JABIRU AIRCRAFT PTY LTD

SERVICE BULLETIN: JSB 009-1
Issue: 1
Date: 4th April 2005
Subject: Alternate Propeller Mount System

Figure 1 – Sample Propeller Installation Details

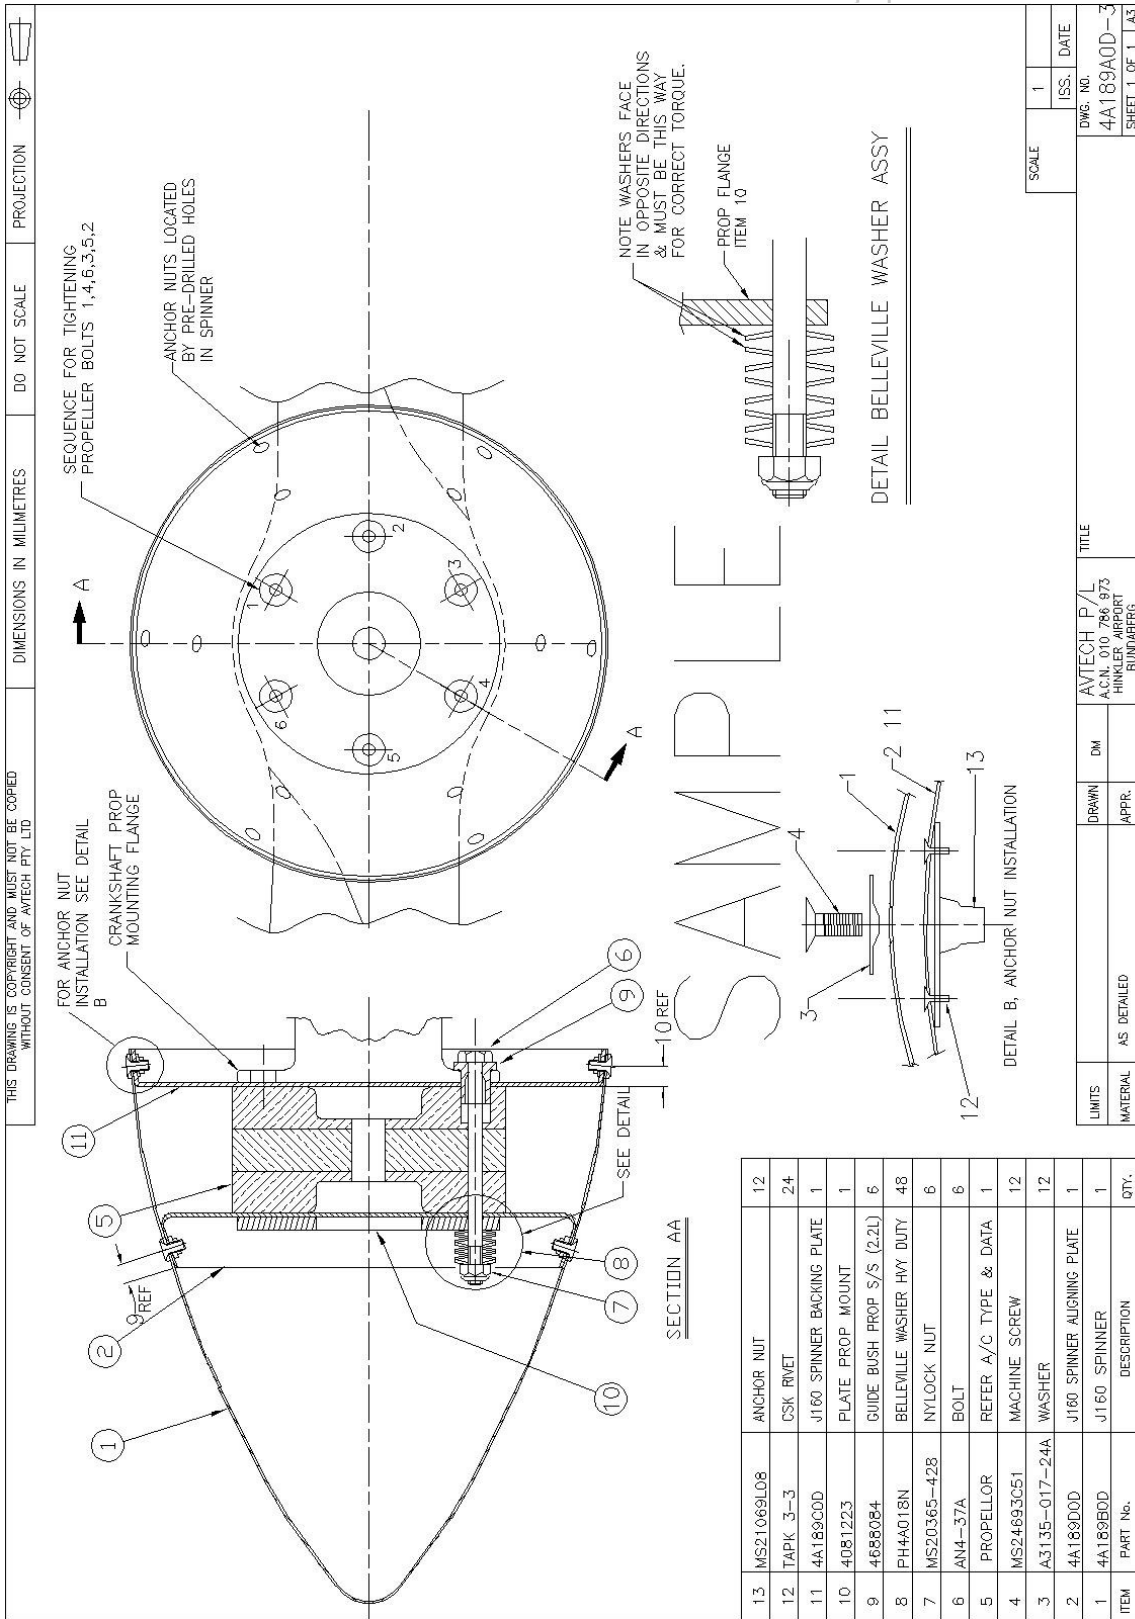
- v) Re-fit the propeller to the aircraft using the longer bolts and Belleville washer stack as shown generally in Figure 1 below (contact Jabiru Aircraft or our local representative for aircraft specific details). Note that the bolts must be oriented with the threaded end facing away from the engine. Details of the variations to the propeller installation for the different Jabiru models are available from Jabiru Aircraft or our local representative.

- vi) Nominal bolt tension is 6 ft-lb. Track propeller in accordance with normal Jabiru procedures, taking care not to exceed 6 ft-lb as tightening the bolts beyond this tension will flatten the washer stack completely and prevent it from moving to accommodate changes in propeller thickness.
